**STAFF REPORT
FOR THE HISTORIC REVIEW BOARD**

FILE NUMBER: DR-17-01

REQUEST: Class II Design Review – Construct New 2-Story Office Building

STAFF REPORT

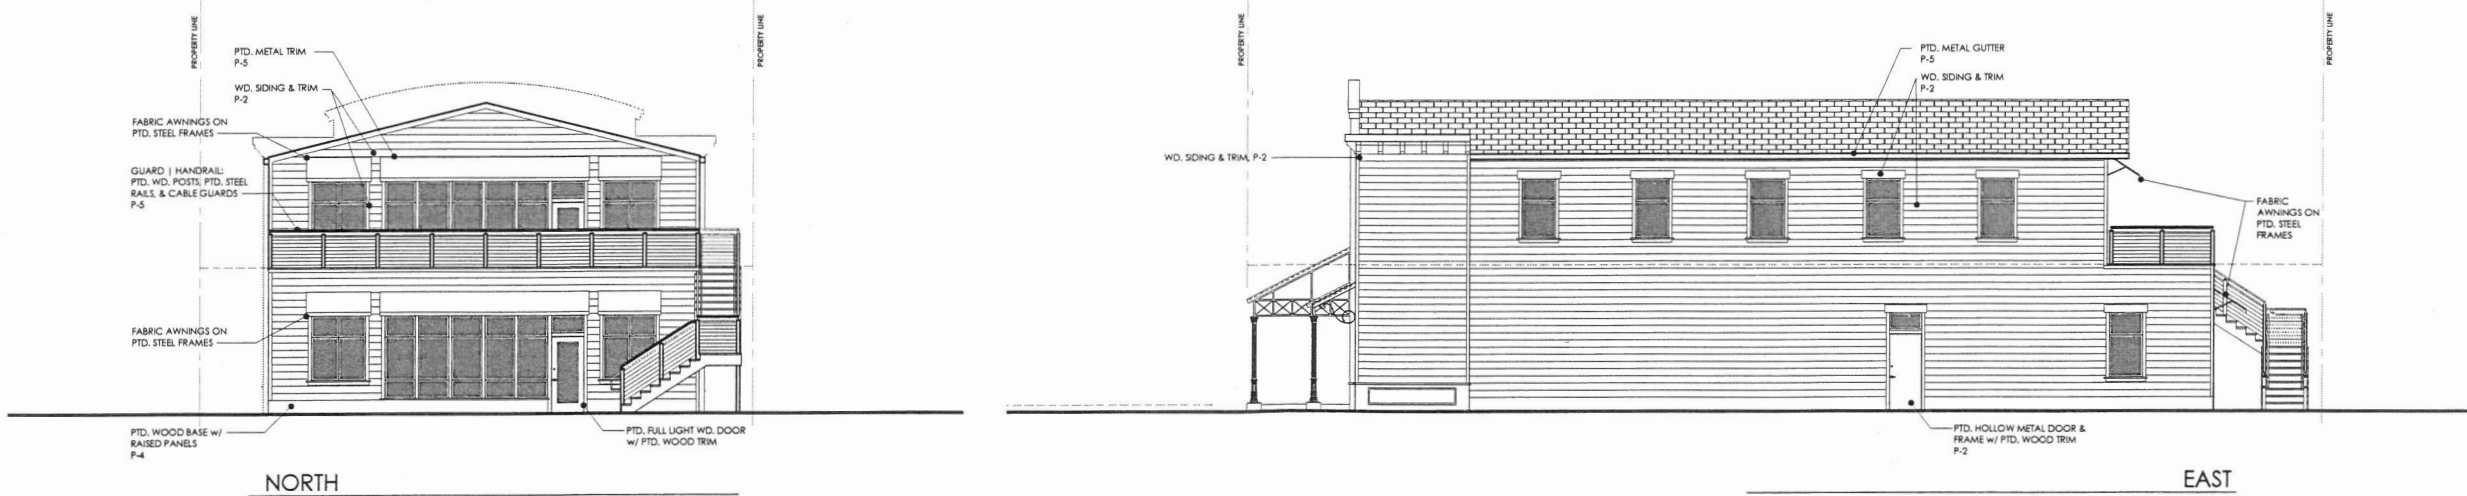
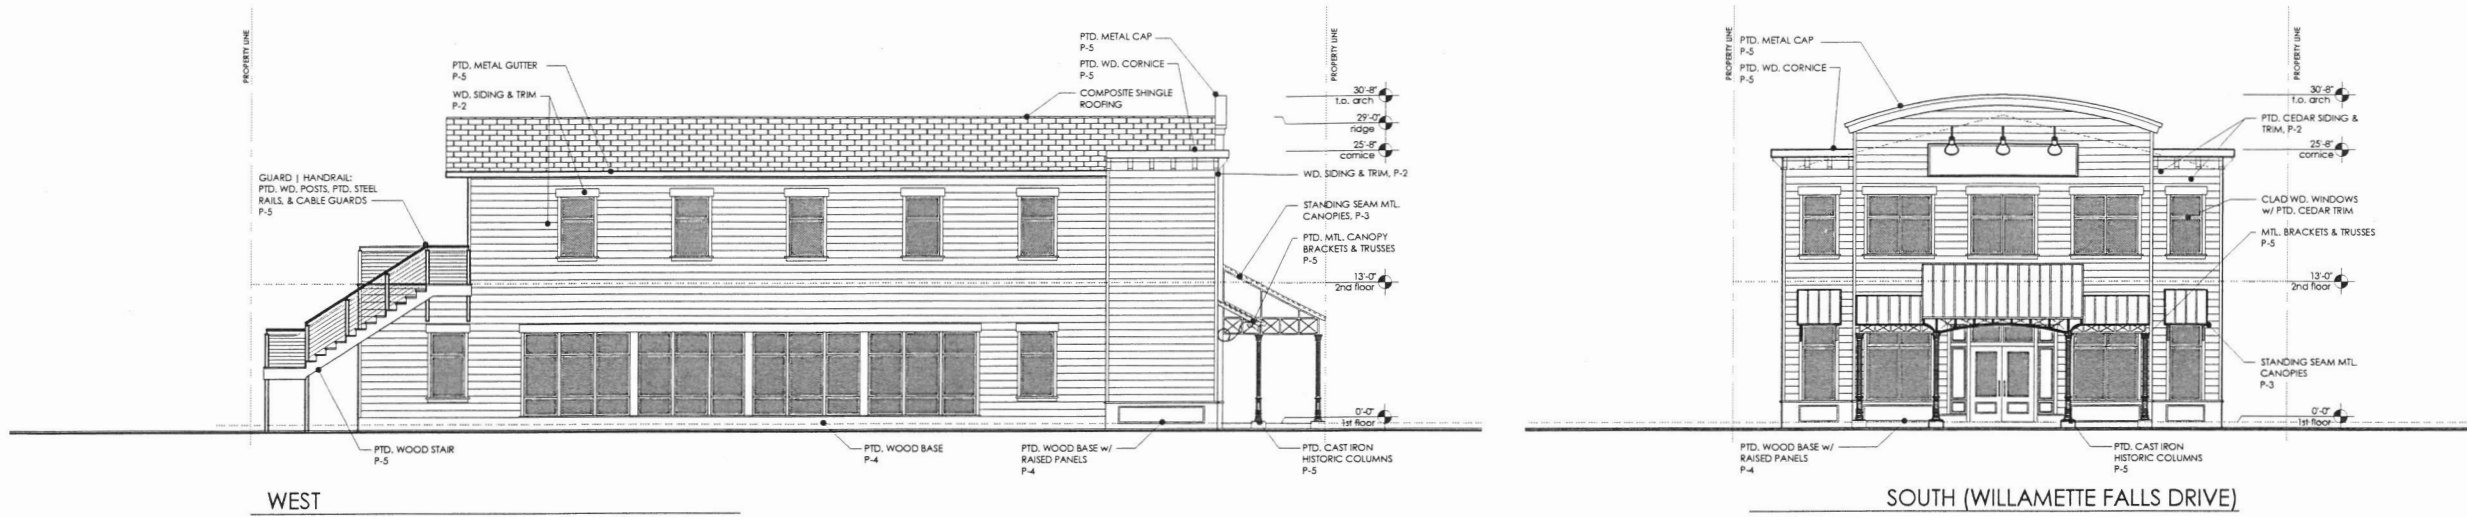
Staff Finding 14: The applicant has proposed a variance to the fabric awning requirement. The applicant proposes a metal awning with metal supports (see applicant submitted plans page DR.2). The awnings will be attached to the building above the pedestrian level windows and front porch. Subject to the approval of the variance request, this criterion is met.
